E5063A-03 S E C E R V Ν F ()

E5063A – ENA Series Network Analyzer

E5063A Chassis Assembly and Rear Panel replacement part number change.

Figure 1-1 New Rear panel and Chassis assembly

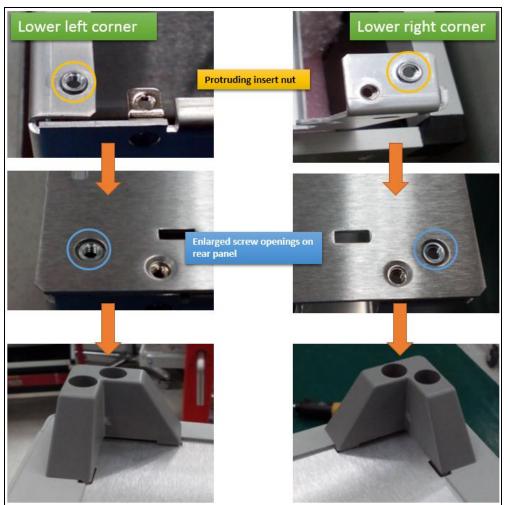
New and improved rear panel and chassis assembly is introduced. Due to mechanical (dimension) change, both rear panel and chassis assembly are required to be replaced with "new" part number on hardware compatibility when either one of the "old" part number is depleted.

The new and improved rear panel and chassis assembly would to further improve the grip between the rear panel and chassis assembly. The insert nut of the chassis assembly is made to be slightly protruded (~1.2mm) resulting in the direct contact (same surface level) when the rear panel (~1.2mm in thickness) is installed.

Replace **both** rear panel and chassis assembly whenever one of the following old part is required to be replaced. Shown in Table 1-1 is the replacement part support plan for E5063A. Refer to Figure 1-1 for the detailed illustration on the changes.
